**DEPARTMENT OF PLANNING
AND DEVELOPMENT**

TITLE: BREAKAWAY PARK SECTION 3

FILE NO: C8-90-0040

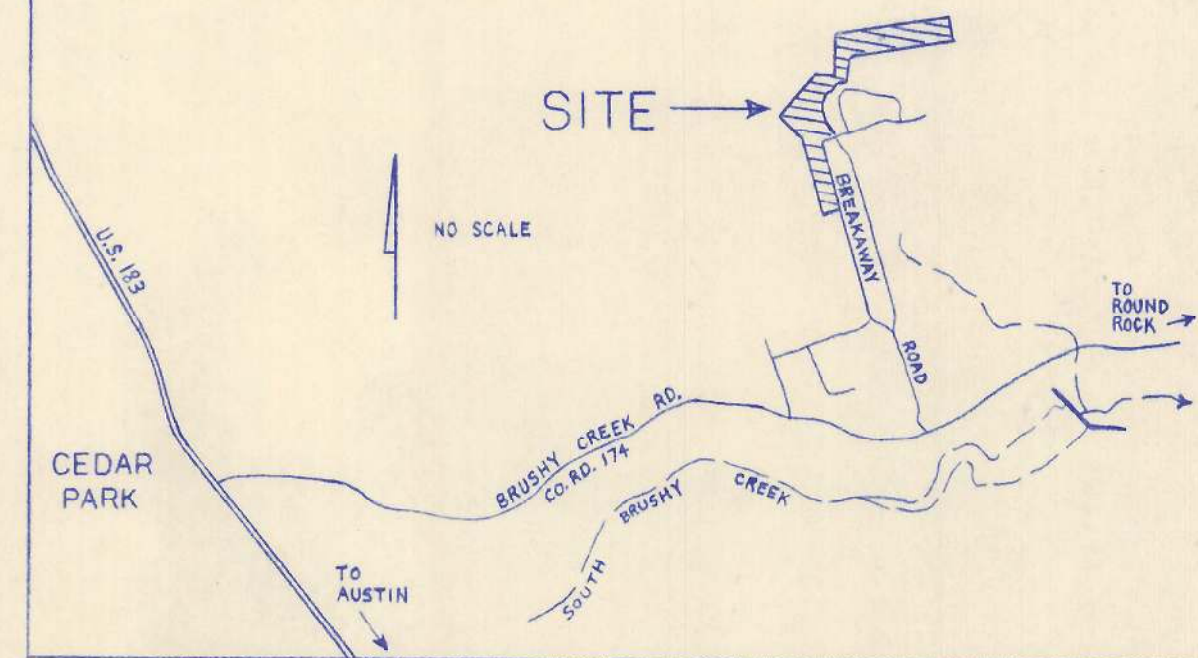
is this also Wilson and Cattle?

Show curve returns

Show proof of dedication for Taku Road - must be dedicated ROW for access to adjacent lots.

68 900040

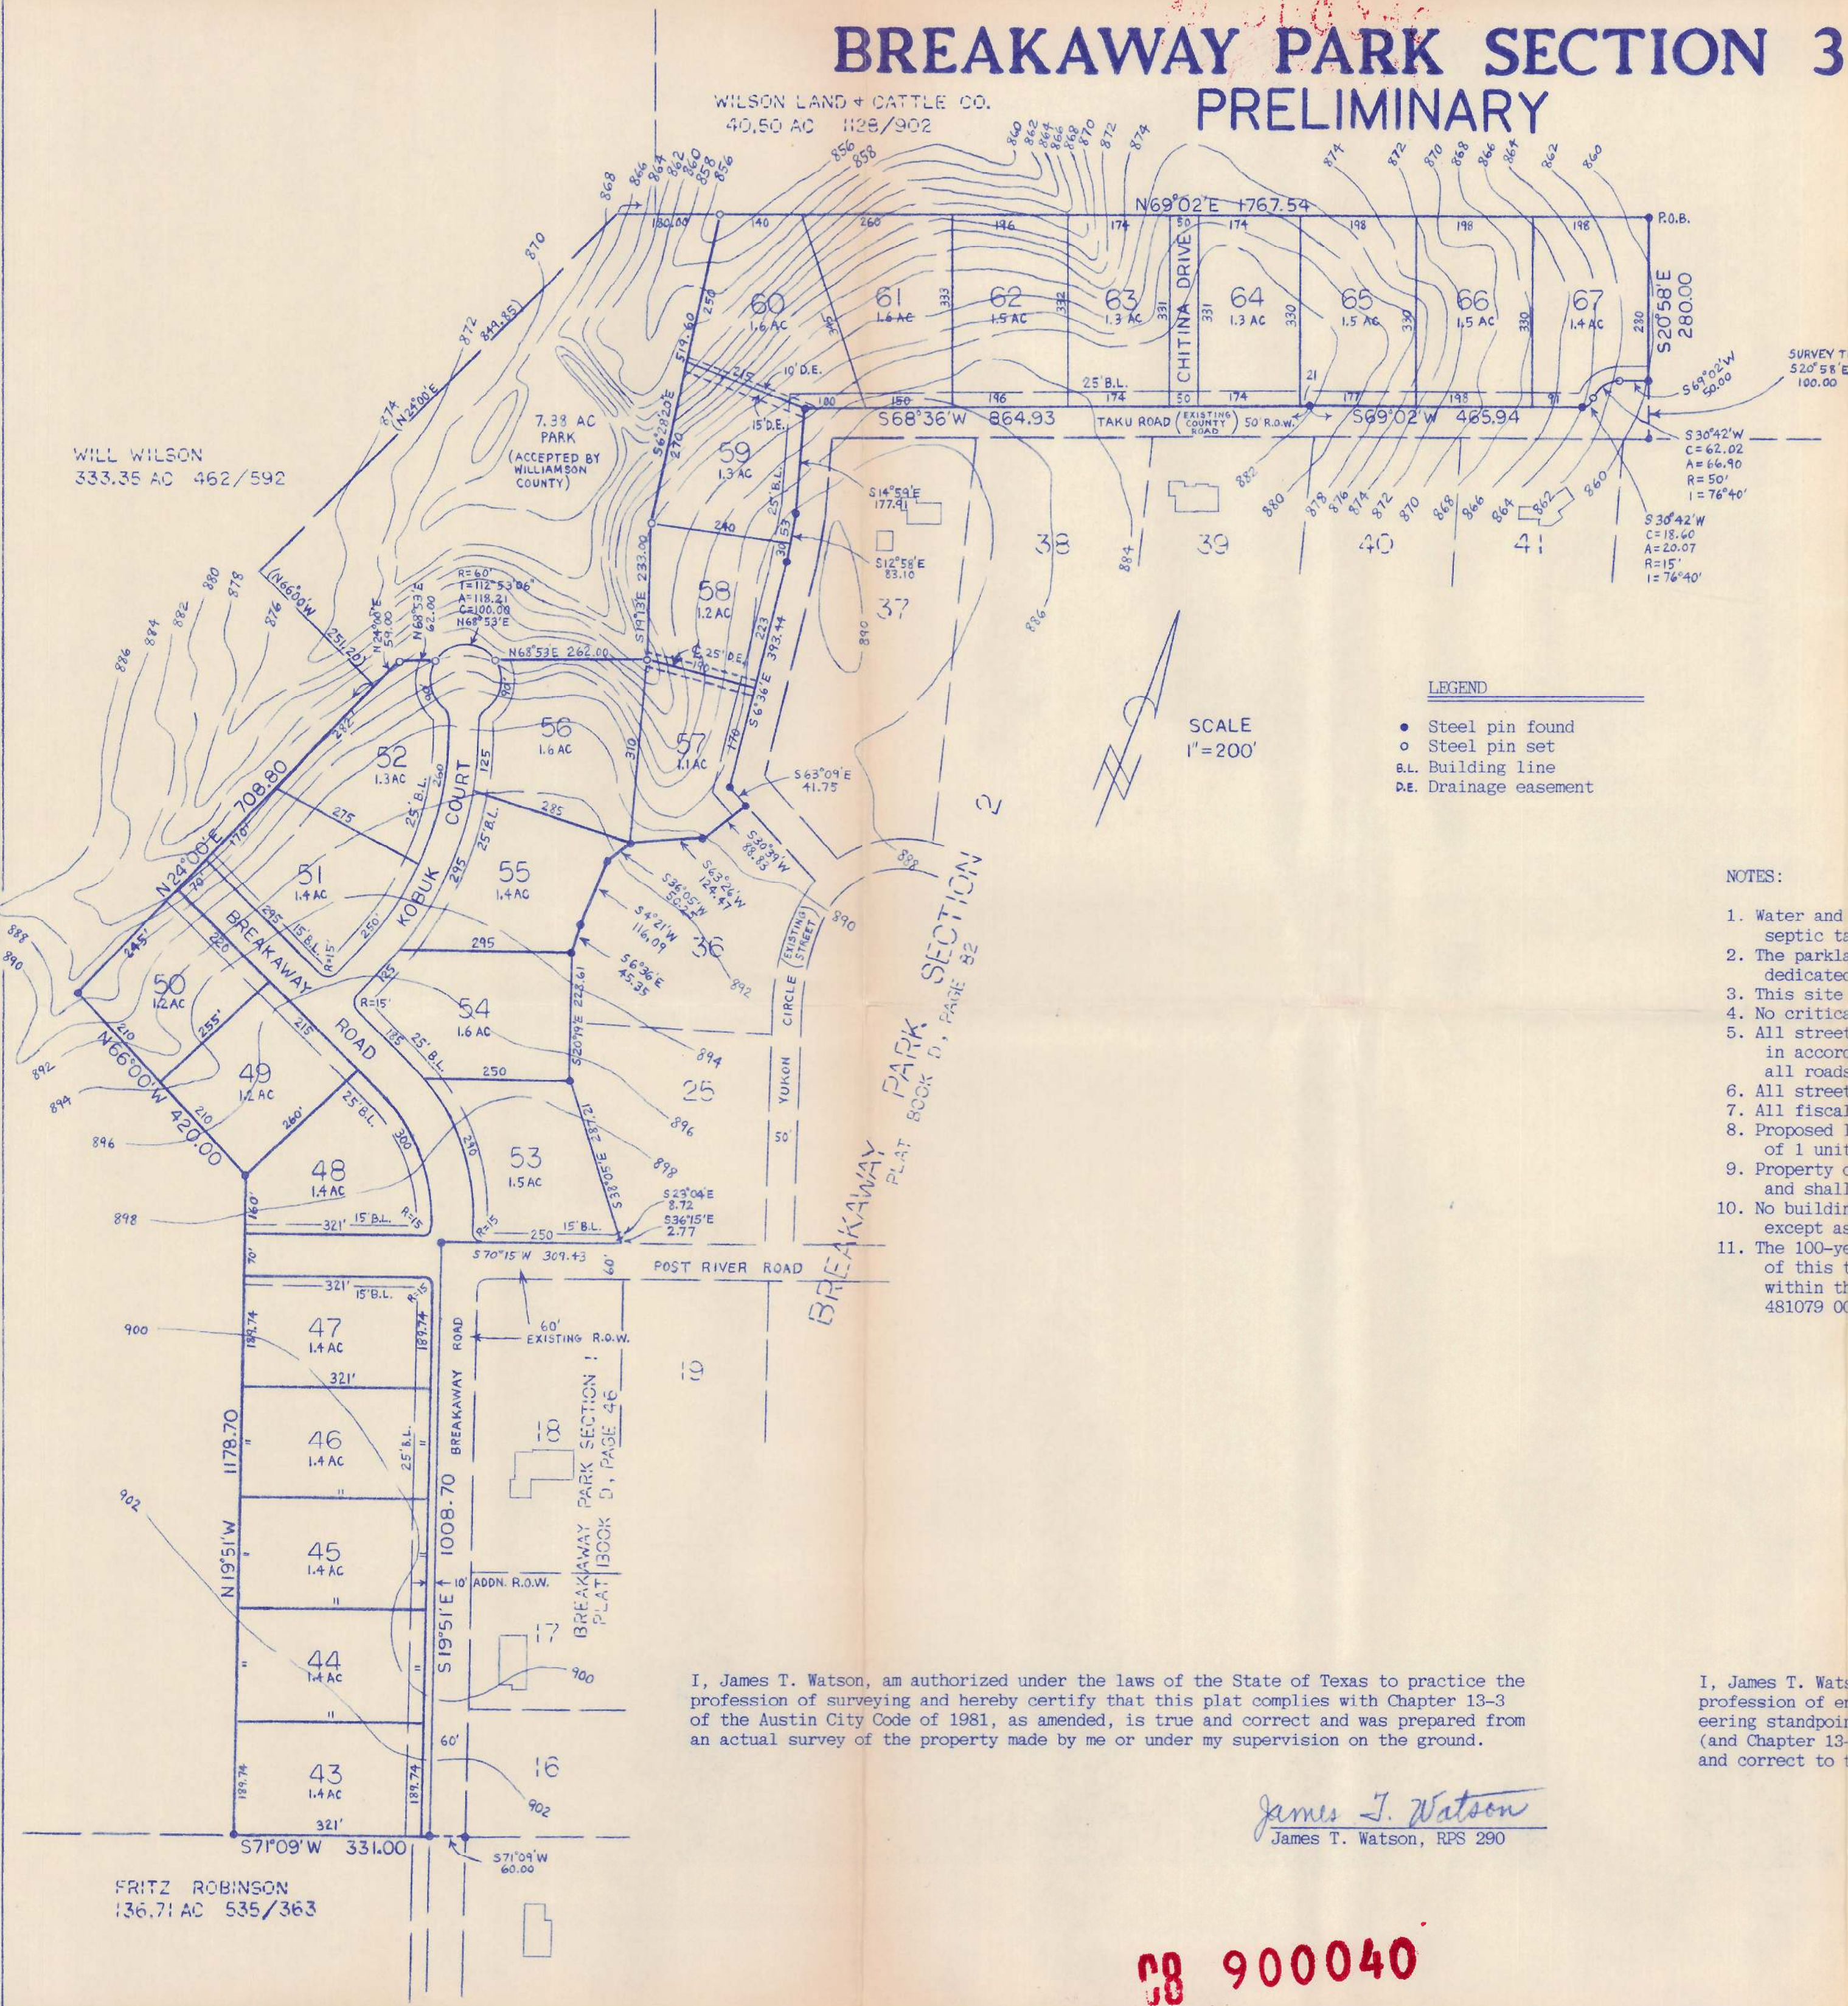
Show address
